SUBJECT: NEW VEHICLE DEMONSTRATION / DELIVERY HOLD – *Supplement #2*
Safety Recall 20S73

Certain 2021 Model Year Econoline Equipped with 7.3L Engine
Engine Cover Thermal Management

New! REASON FOR THIS SUPPLEMENT

- *Attachment III: Update to Technical Instructions to clarify installing of driver or passenger side thermal patch.*
- *Labor: Update to Labor Allowance description.*

FIGURE 2

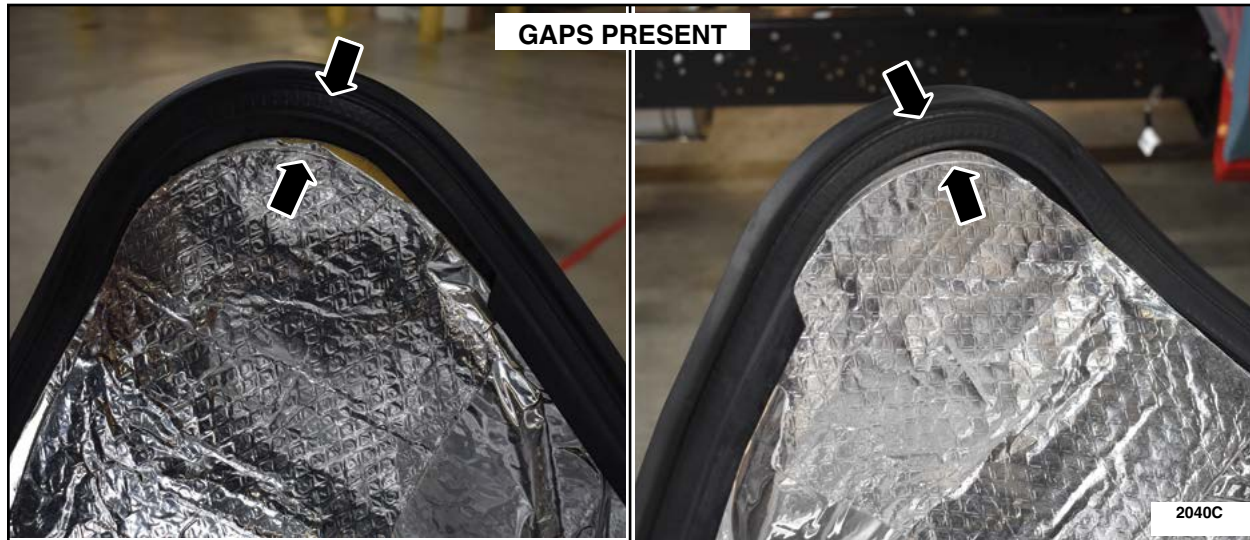
4. Are there any gaps present between the thermal shield and the engine covers weatherstrip on either side of the engine cover as shown in Figure 2?

NEW ! **NOTE:** *Thermal patch only needs to be installed on the side that has a gap present.* The shorter thermal patch is installed on the driver side of the engine cover and the larger thermal patch is installed on the passenger side of the engine cover. The patches will match what is currently in place on the engine cover but will be placed on top to cover gaps present.

YES - Proceed to the Thermal Patch Kit Installation Procedure.
NO - No further action is required.

FIGURE 3

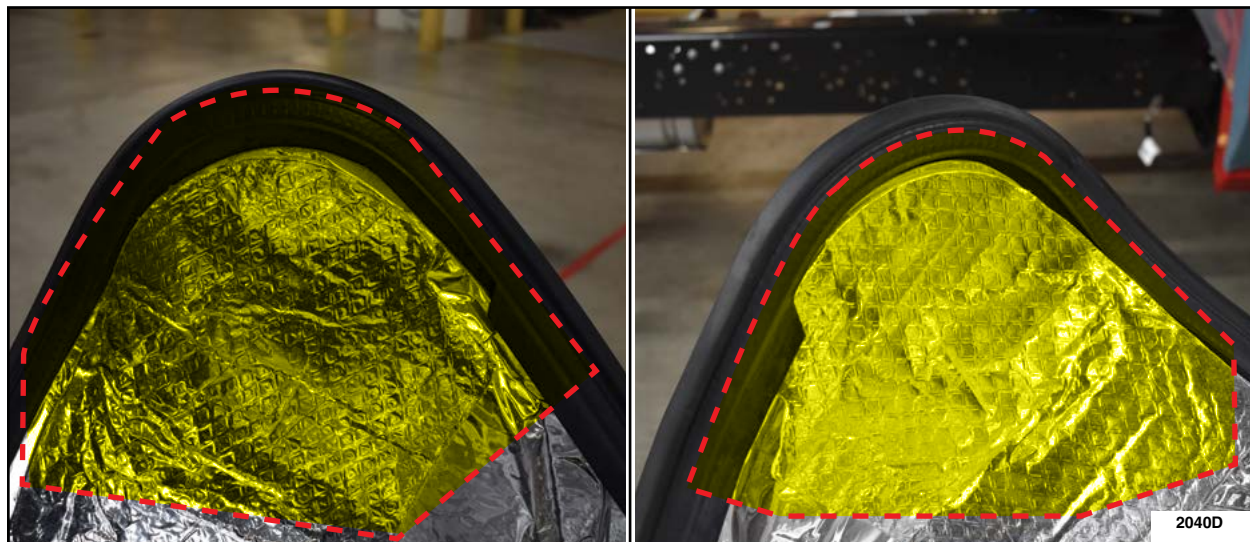
1. Clean the inside surface of the weatherstrip and the existing thermal shield with isopropyl alcohol and a clean shop cloth. See Figure 3.
